Proposed Specification for additional circuit to be added to Eurotext CF70206.

The device resulting from this change will be known as the **CF70207**, with a device ID to be decided (it can either be the same as the CF70206, or a new unique device ID). The internal software for the CF70207 will be the same as the CF70206.

Figure 1

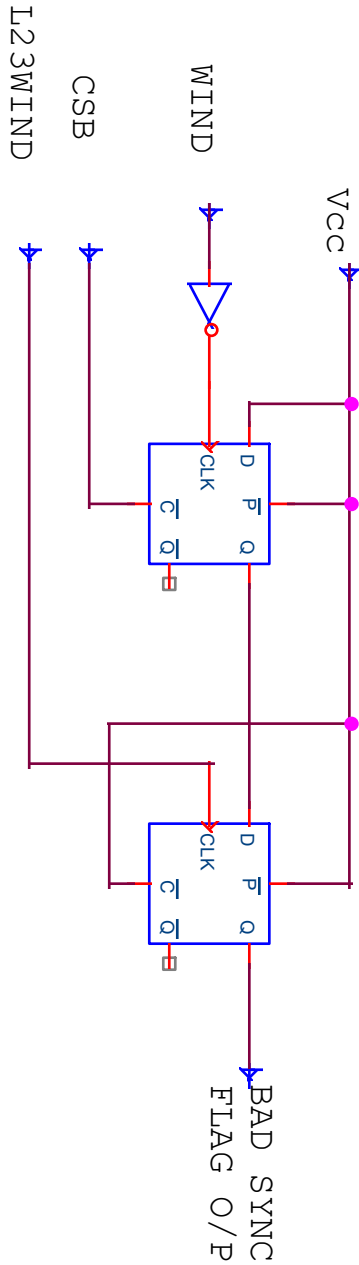
In order to overcome a problem with the synchronisation from some VCRs, it is proposed to add the equivalent to the circuitry shown in Figure 1 to the design for the Eurotext CF70206.

The circuit in figure 1 is intended to detect the situation when the Eurotext phase locked loop causes a phase error with respect to bad VCR syncs before line23. Waveforms for the circuit are shown on the page following Fig 1.

The first d-type flip flop is clocked on the falling edge of the WIND signal, and thus the Q output will be set to a 1. Shortly after this, the sliced sync from the VCR should occur, clearing the Dtype, and setting the Q output to a 0. When the L23WIND signal occurs on line 23, the Q output of the first D type should be a 0 as just described, and the rising edge of the L23WIND signal will clock this state into the second Dtype, resulting in its Q output being set to a logic 0 (GOOD sync).

If the sync from the VCR fails to occur in the time between the end of the last WIND signal and the start of the L23WIND signal, then the 2nd Dtype will see a 1 on its D input when the L23WIND signal goes high, and the Q output will be set to a 1 (BAD).

Figure 3

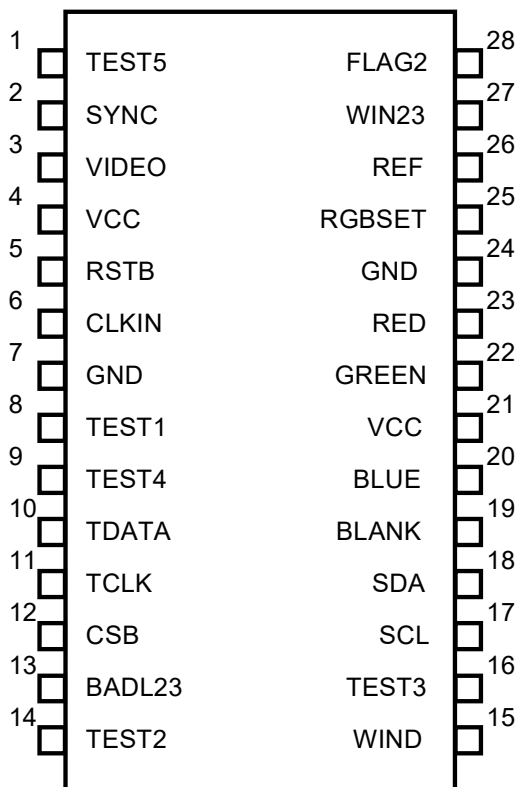
The output obtained from the additional circuit will appear on what used to be the "MUTE" pin (pin 13) on the CF70206. This output (BADL23) will be a logic 0 for a good sync and a logic 1 for a bad sync.

The proposed pin out for the CF70207 is shown in Figure 3.
